## FIELD INSPECTION

| Project Name:                | Mountain Valley Pipeline             | Inspector:              | Marshall Willis             |
| Spread I:<br>Franklin County | STA 14018+47- 14042+25<br>MVP-MLV-31 | Weather (Wet/Dry/Rain): | Dry                         |

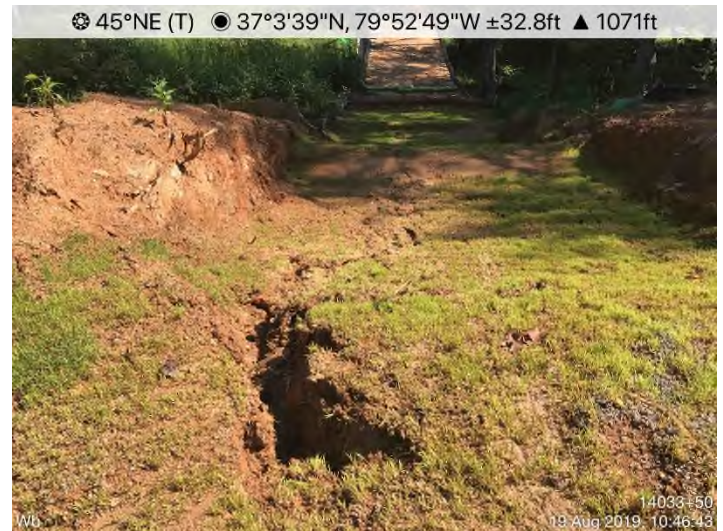
STA 14019+91: Stabilize slopes and area surrounding MLV-31.  
 STA 14033+50 to 14034+50: Waterbar maintenance required.  
 STA 14034+50: Sediment off ROW.

Fig. 2: **STA 14033+50 to 14034+50** – Maintain waterbars.

**Recommended Corrective Action:** Maintain and install all controls per the approved plan and PSS&S.
